HISTORIC AND DESIGN REVIEW COMMISSION

November 18, 2020

HDRC CASE NO: 2020-471
COMMON NAME: 335 TRAIL
LEGAL DESCRIPTION: NCB 6078 BLK 2 LOTS 9 THRU 14 & 17 THRU 20
ZONING: MF-33, H, RIO-1
CITY COUNCIL DIST.: 1
DISTRICT: River Road Historic District
APPLICANT: David Morin/MNO Investments
OWNER: David Price
TYPE OF WORK: Consideration and action of an application for a multi-unit residential development:

1. Window Section – Please see below. Windows will comply with historic design guidelines for trim, sill details, and installation depths.

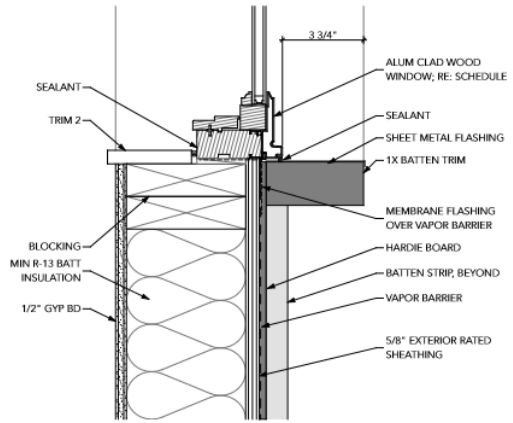
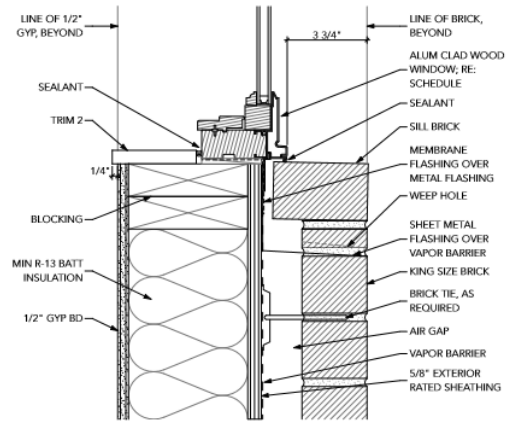
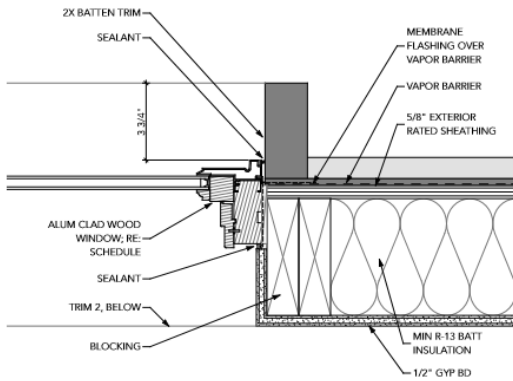
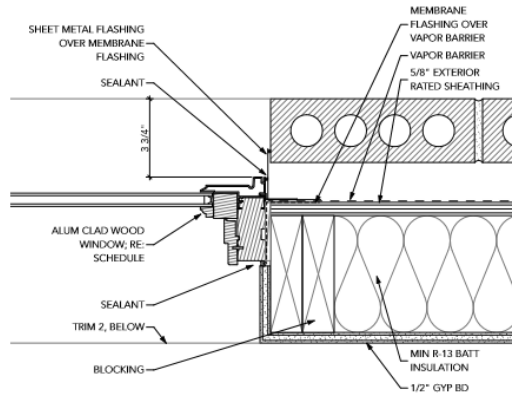
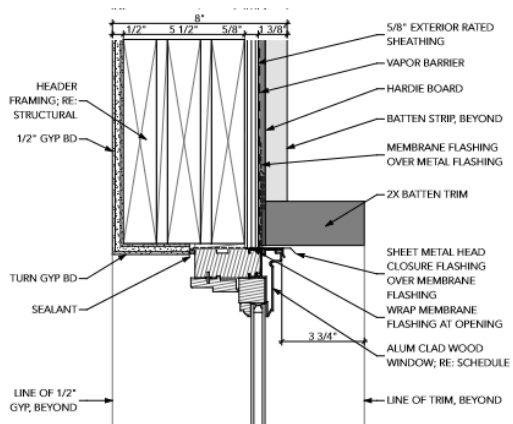
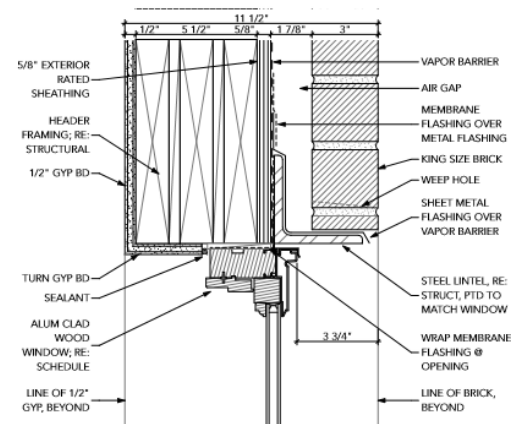
- o. **WINDOW MATERIALS** – Per the applicant’s submitted documents, an aluminum clad wood window is to be installed. Additionally, the applicant has submitted a window installation detail noting that windows will be sufficiently recessed within openings, per staff’s standards for windows in new construction. Staff finds that all standards for windows in new construction should be followed. These standards are found above in the applicable citations. The installation sections that the applicant has submitted are not consistent with staff’s standards in regards to installation depth, sill profiles, and trim profiles.
